Sheringham Shoal and Dudgeon Offshore Wind Farm Extension Projects

Draft Statement of Common Ground: Natural England
(Offshore)

Revision A
March 2023
Document Reference: 14.7

Plate 1: Location (Light Blue Dots) of Evidence of Previous Native Oyster Beds within Cromer Shoal Chalk Beds (CSCB) MCZ

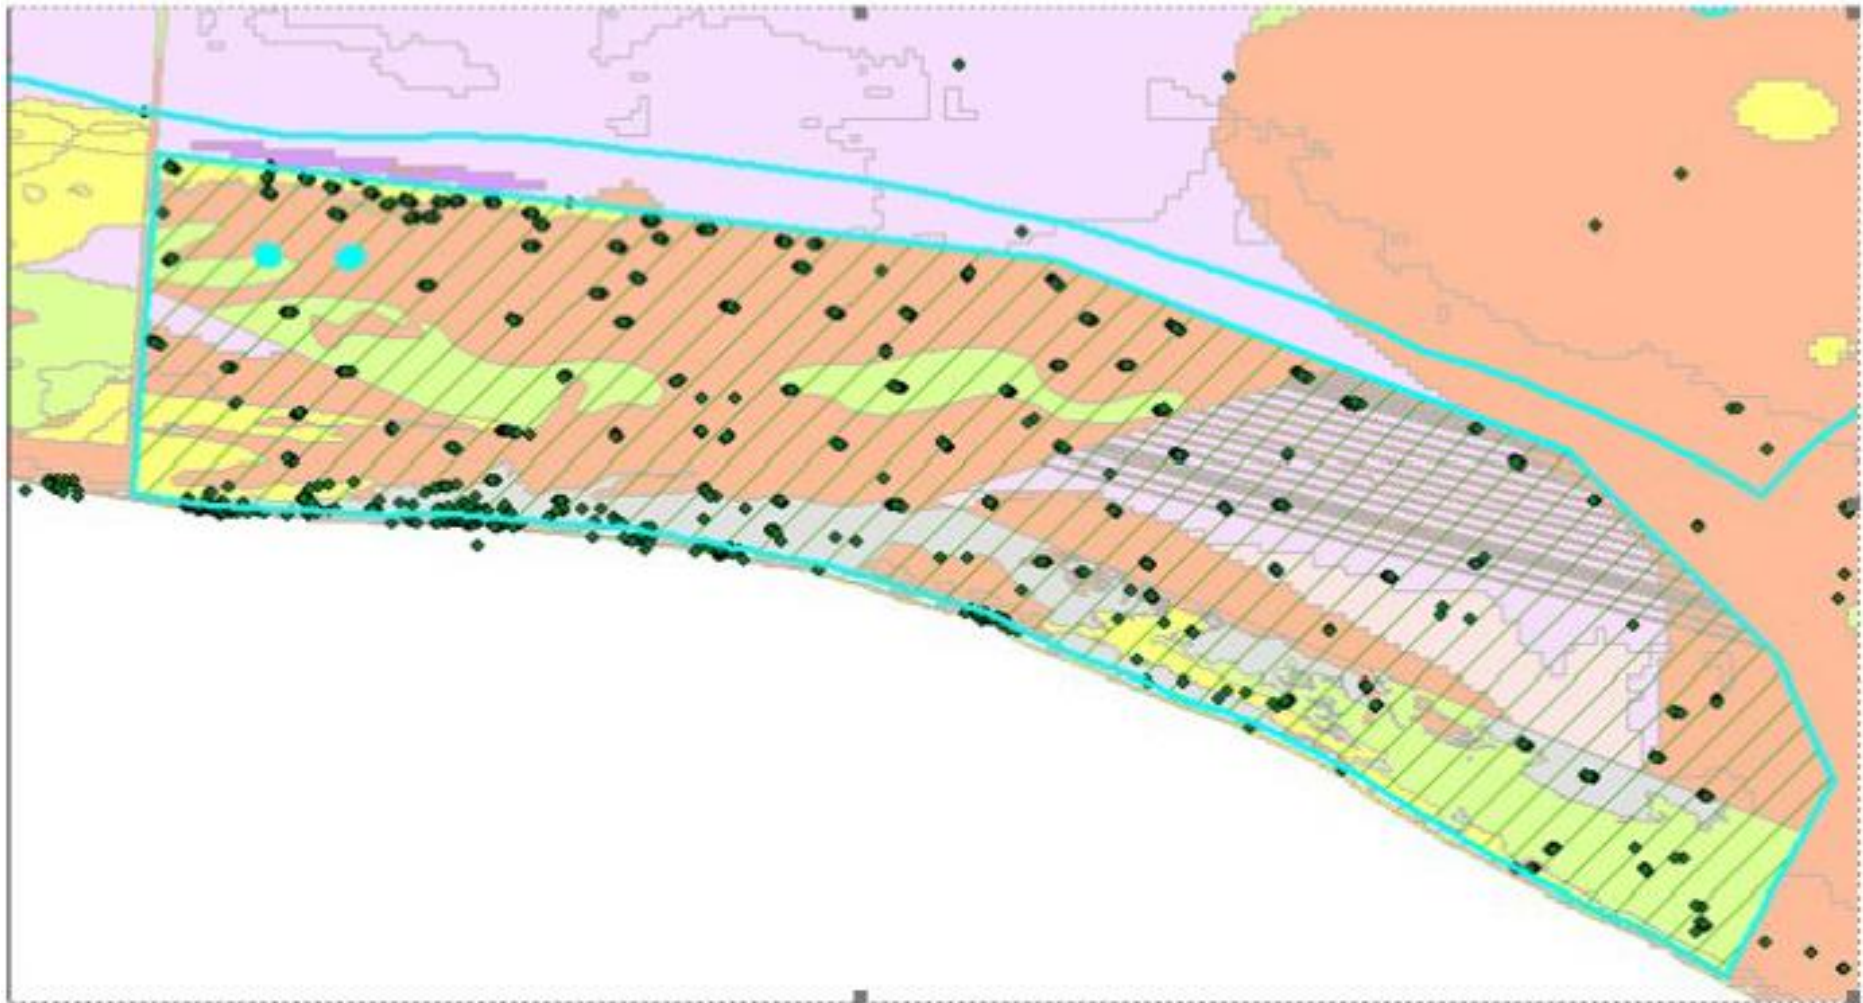
ID	Agreement	Natural England	MMO	Cefas	The Wildlife Trusts	EIFCA	Notes
7.5	Do you agree that the area of search for determining feasibility of oyster reef planting should focus on the areas identified in Plate 1 (see below) of Natural England's advice broadening out to the wider north western portion of the MCZ and focus on subtidal sediment features avoiding potentially sensitive habitats e.g. chalk, reef etc.?	Agreed	Defer to Natural England	N/A	Not present	Not agreed	<p><u>EIFCA</u></p> <p>Concerns raised that the 'previous oyster bed evidence' relates to historic fisheries shell deposit grounds. In this context, we don't agree that Plate 1 should be titled "...evidence of previous native oyster beds..".</p> <p>Any potential site should be selected based on current environmental factors that are most agreeable to support the success of the MEEB.</p> <p>An effective appraisal of all environmental factors, to gain an understanding as to why native oysters have not re-established naturally should be undertaken. It would also be beneficial to find out whether native oyster beds were present in the MCZ historically – although it could be difficult to find any evidence for this. It should not be assumed that fishing is the only cause of decline in oyster stocks and distribution, and all relevant environmental factors must be considered.</p> <p>As this is an MCZ social and economic factors should be considered when evaluating any intervention, even those for conservation benefits such as MEEB.</p>
